Proposal #06: 1660-03-67
Marquette-Prairie Du Chien
Mississippi Rvr Structure
B-12-0027
USH 18
Crawford County

1660-03-68, WISC 2019 070
Marquette-Prairie Du Chien
Mississippi Rvr Structure
B-12-0028, 0029, 0030
USH 18
Crawford County

Letting of January 15, 2019

This is Addendum No. 01, which provides for the following:

Schedule of Items

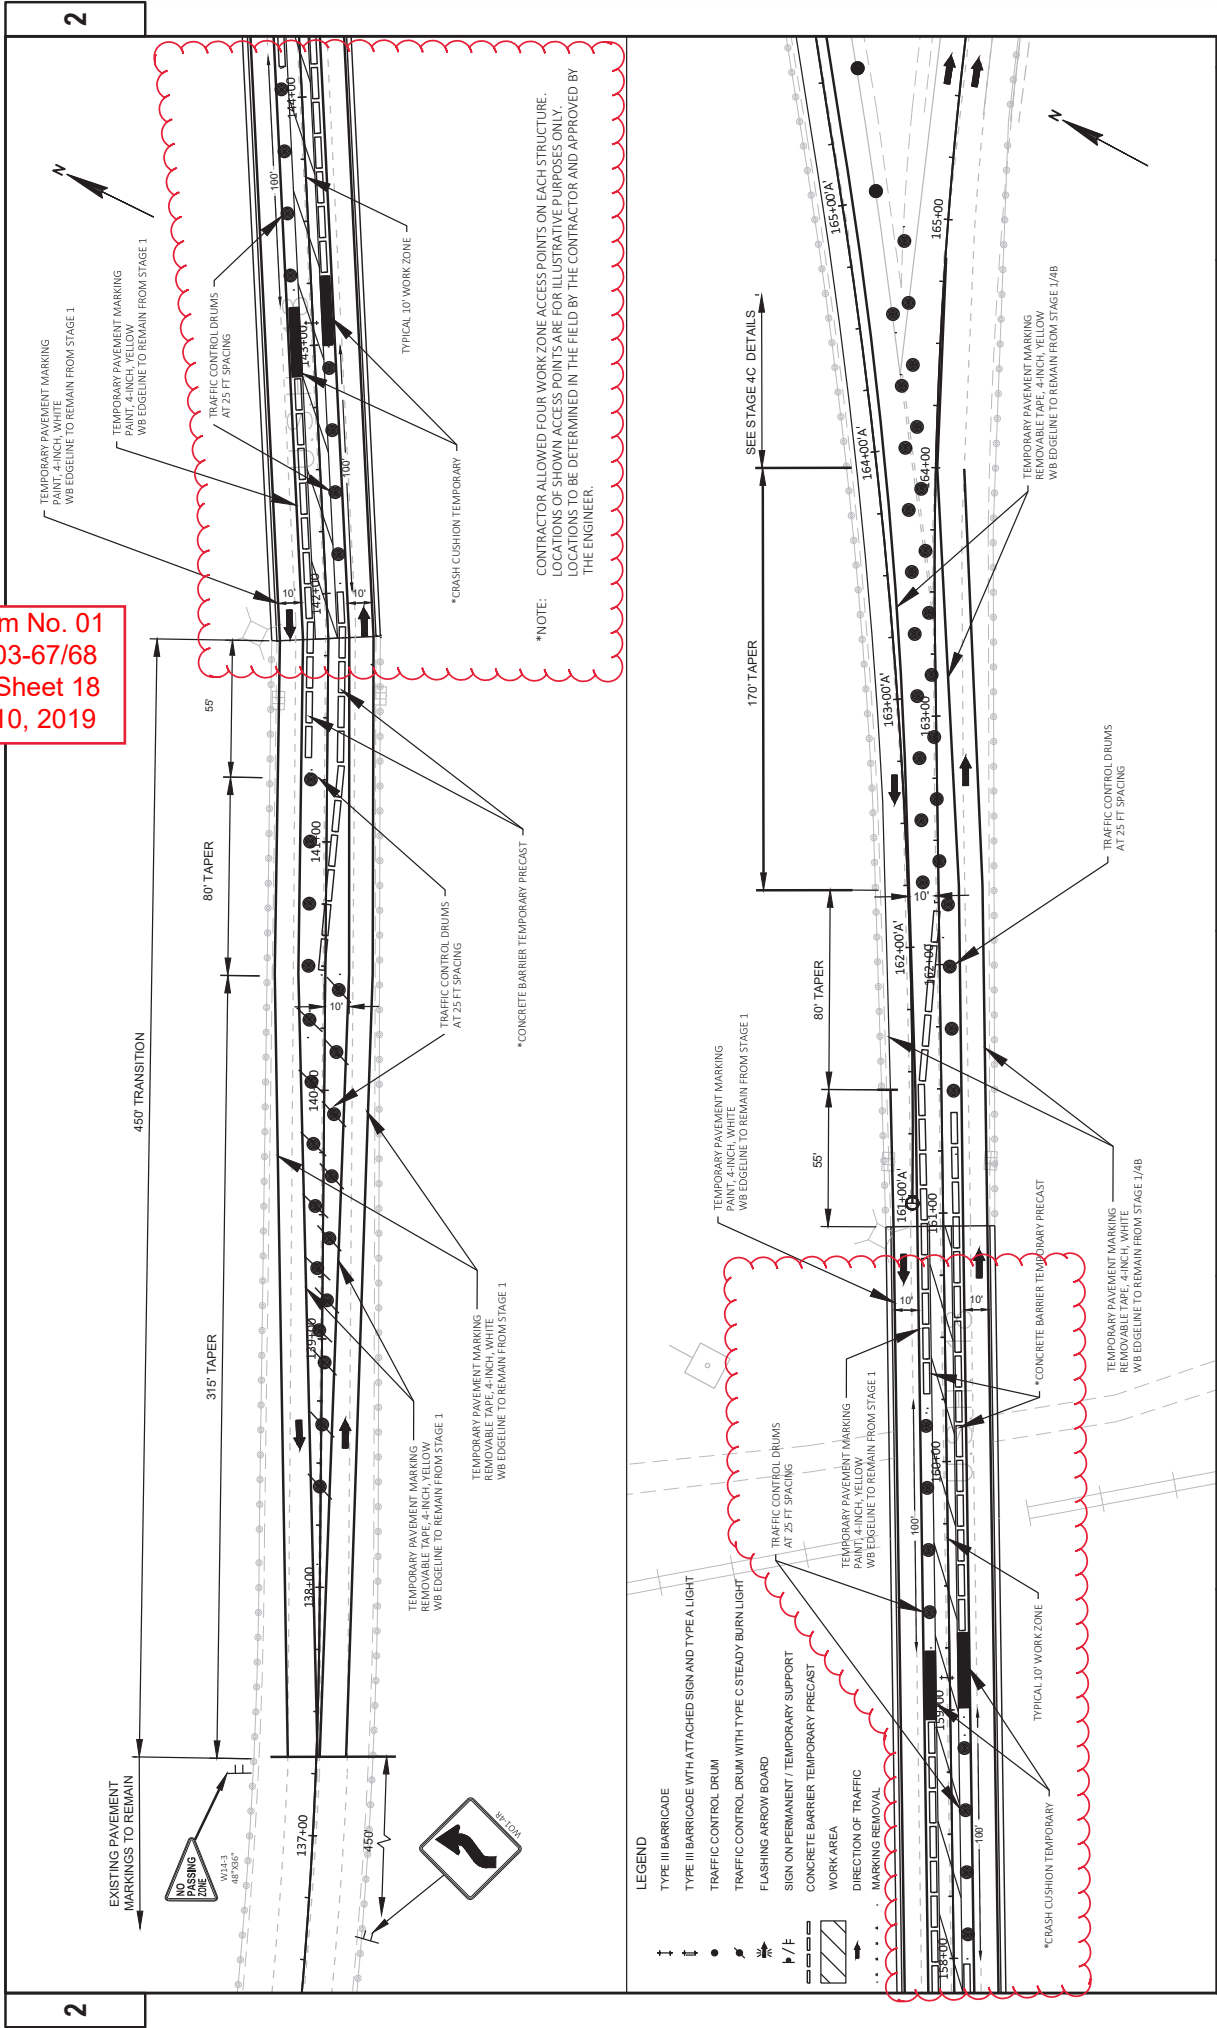
Attached, dated January 10, 2019, are the revised Schedule of Items Page 5.

Revised Bid Item Quantities					
Bid Item	Item Description	Unit	Old Quantity	Revised Quantity	Proposal Total
603.8000	Concrete Barrier Temporary Precast Delivered	LF	10,714	-500	10,214
603.8125	Concrete Barrier Temporary Precast Installed	LF	21,779	-500	21,279
614.0905	Crash Cushions Temporary	EAC	1	8	9
